FOR PERCOLATION TESTING AND SITE EVALUATION

Subject: Variance letter request for 1435 Marriottsville Road – Lot 4, A52784,

Subject: Resubmission of Percolation Application Plan for
1435 Marriottsville Road – Lot 4, A52784,

RE: 1435 Marriottsville Road -Lot 4, A527284; Percolation Application Plan

DRAWING NO. 1 OF 1
C-1

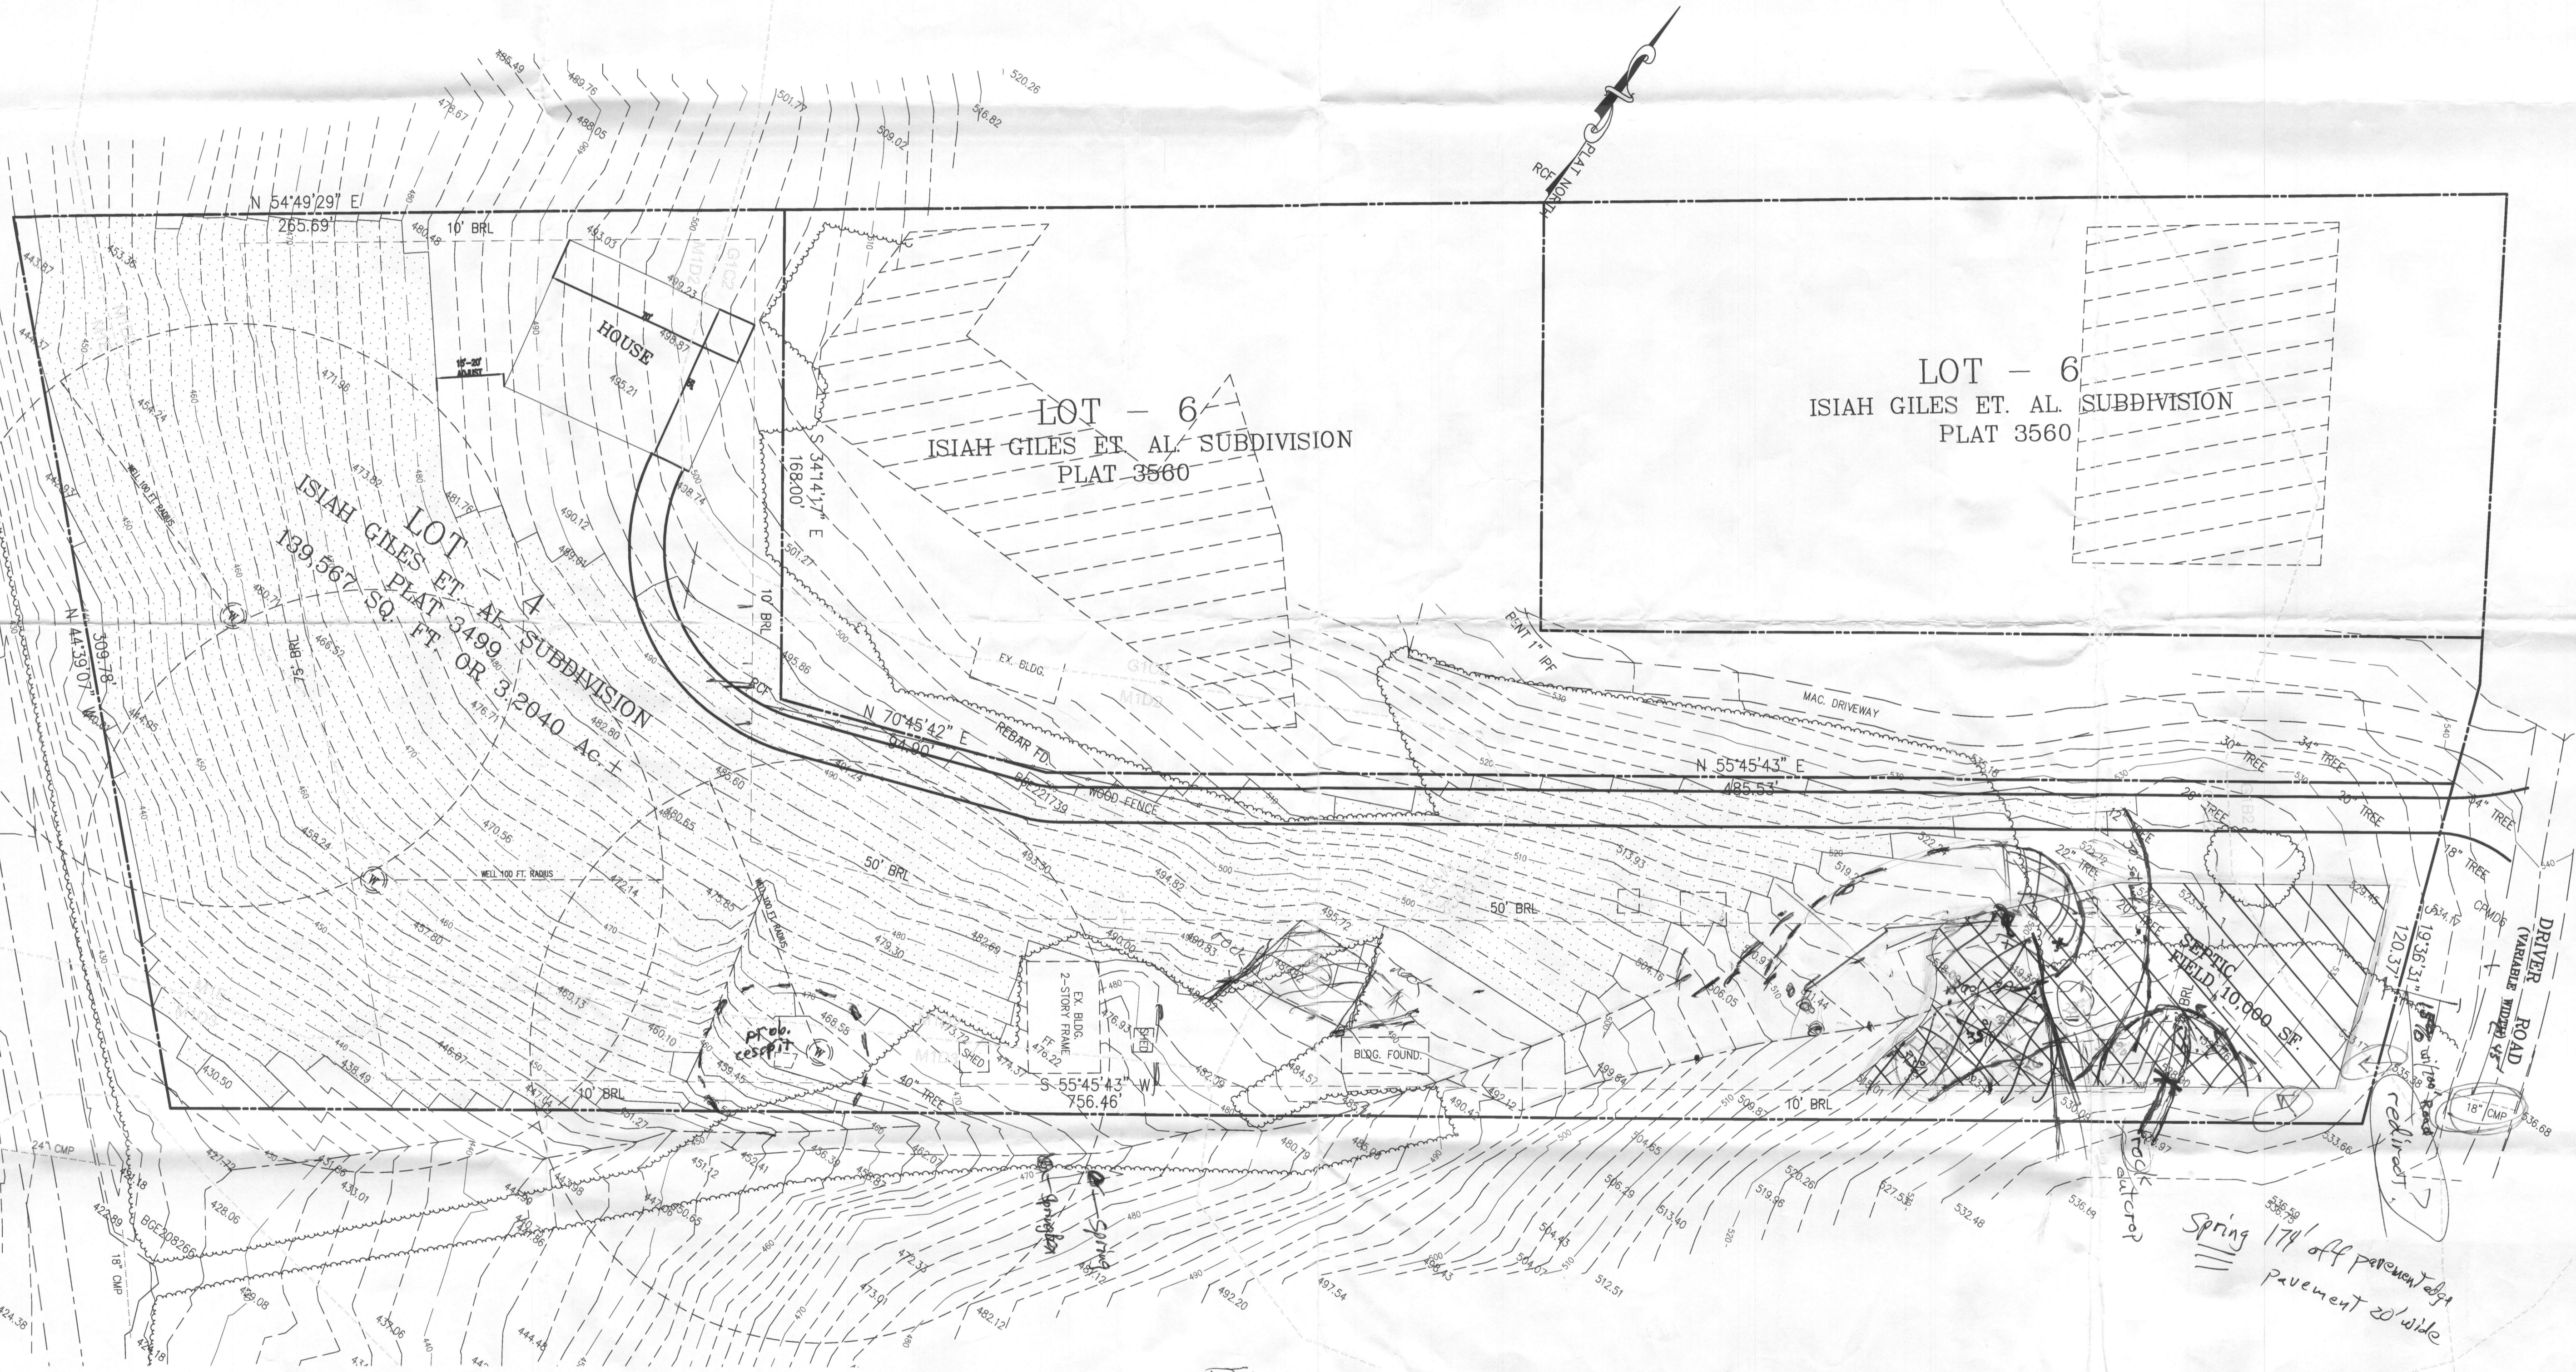
? Filling Spring?

DRAWING NO. X OF X
C-0

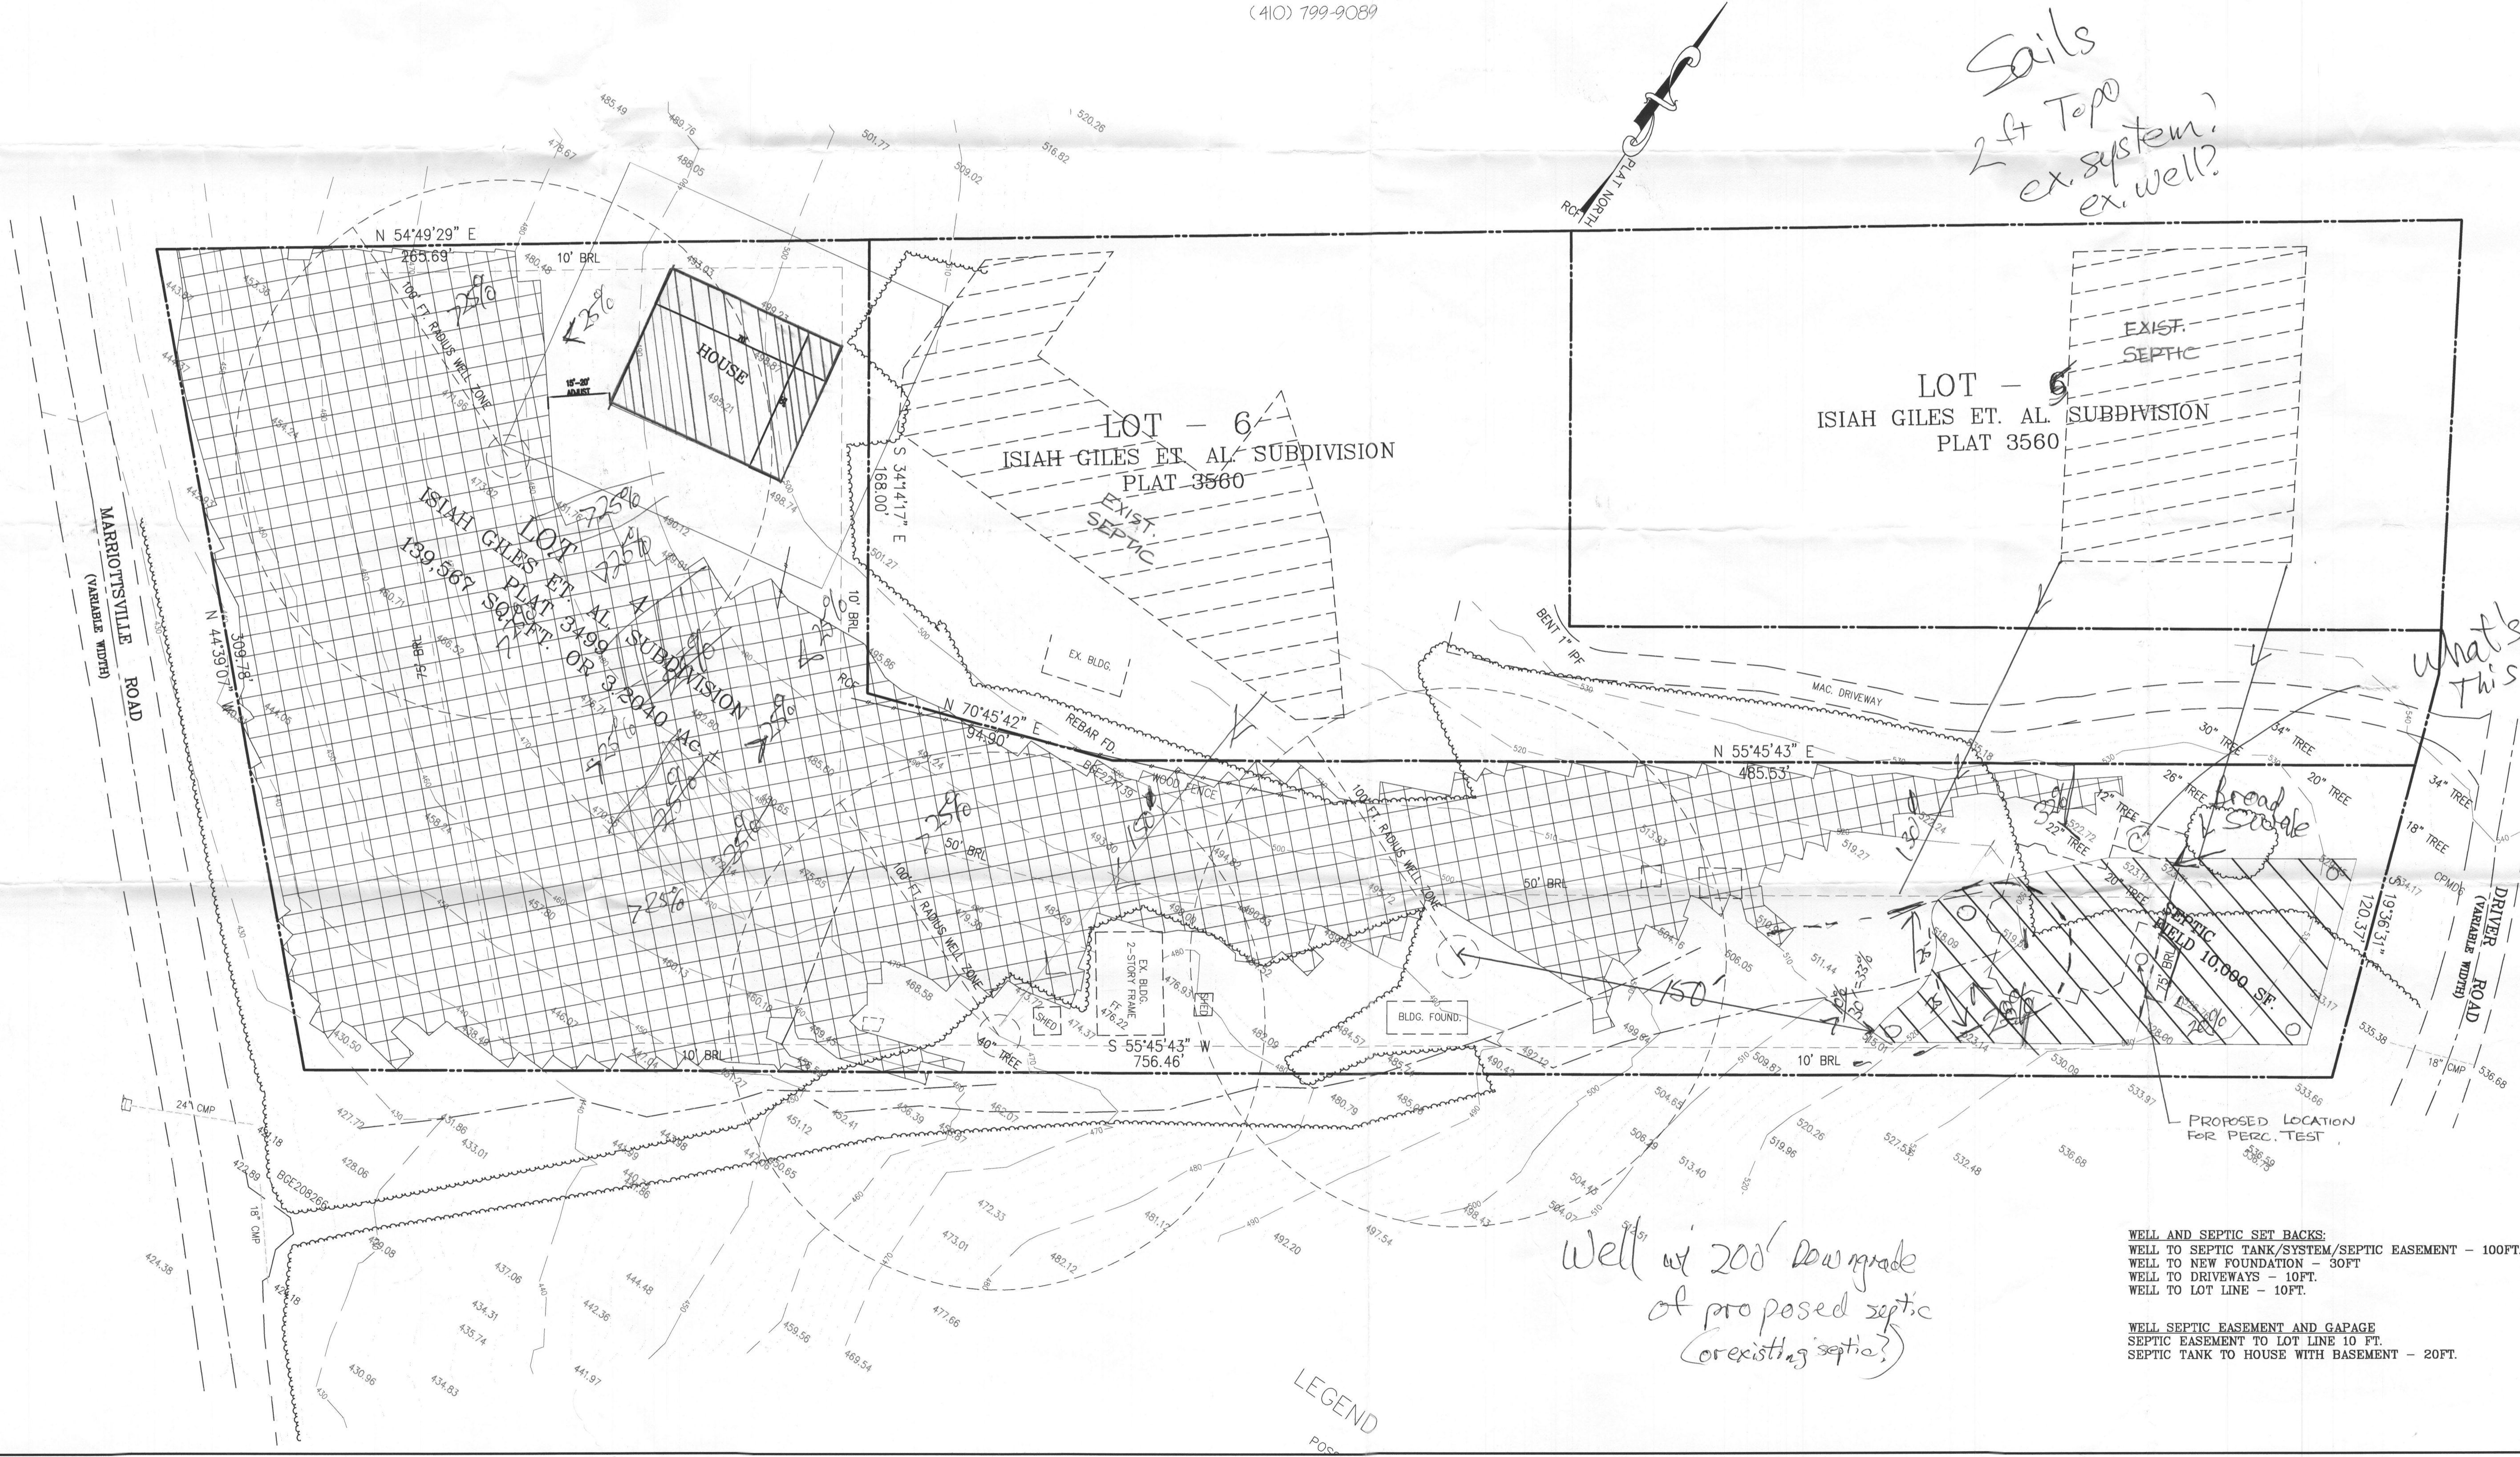
650' Effluent Line
-40' Head

Sails
2ft Topo
ex. system?
ex. well?

what's this?

DRAWING NO. 1 OF 1
C-1

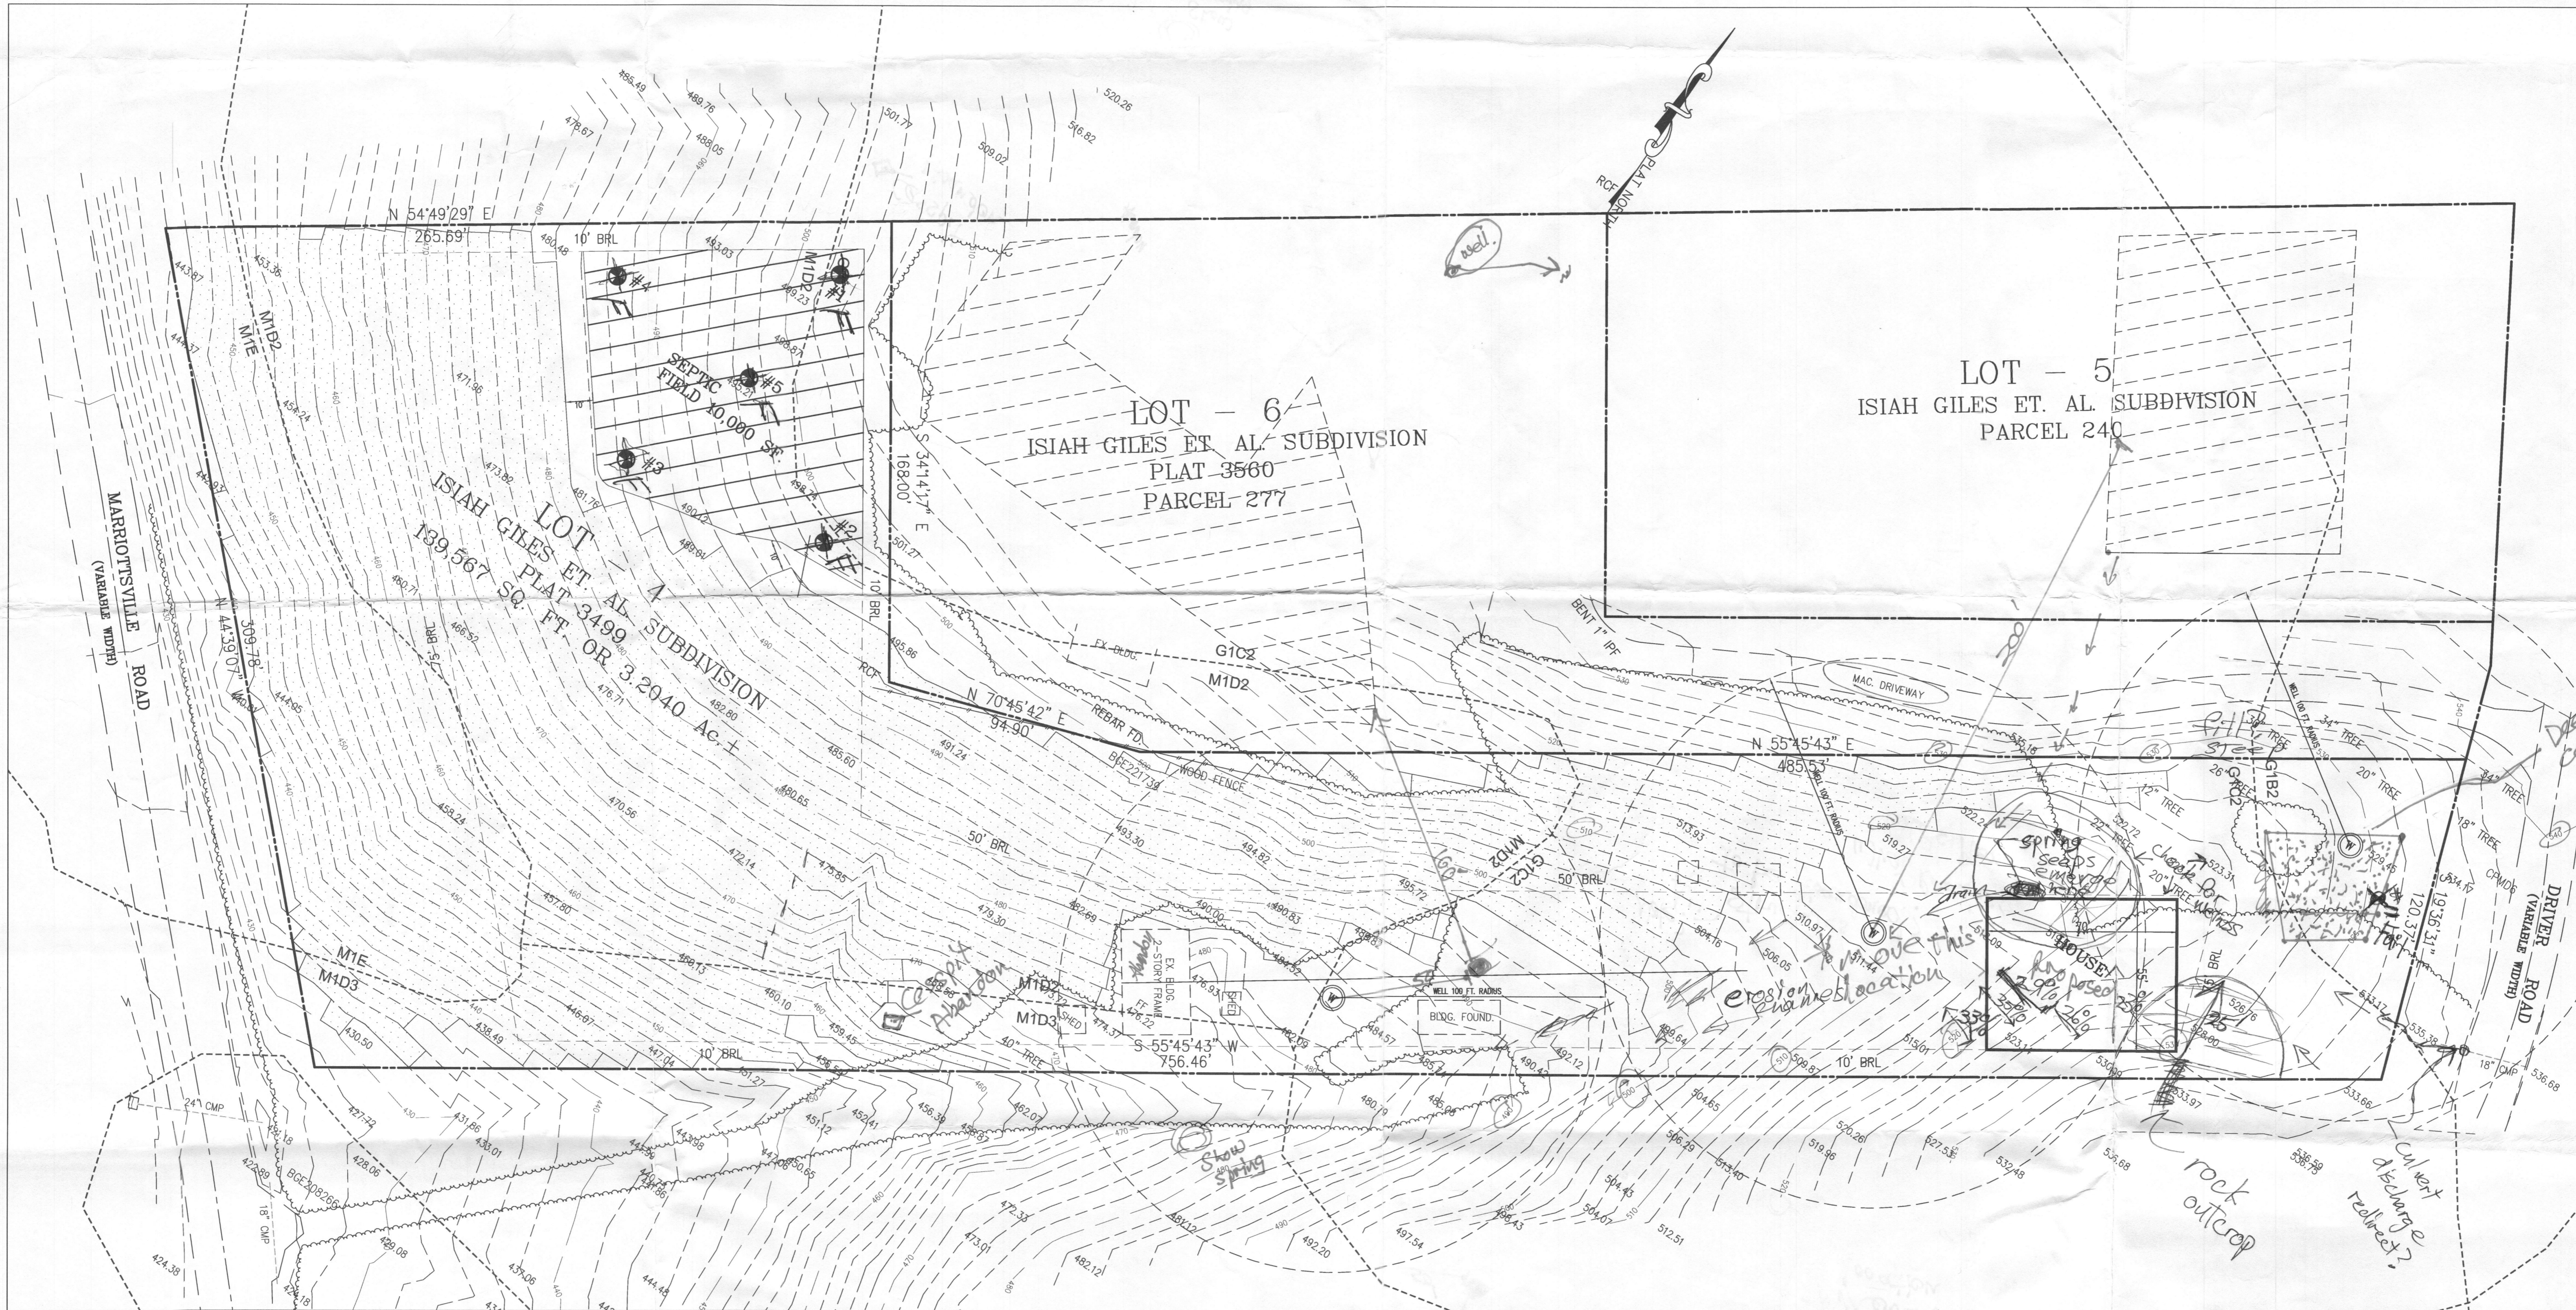
Well at 200' Downgrade
of proposed septic
(existing septic)

Note? All structures to be abandoned? what remains? Labels Please
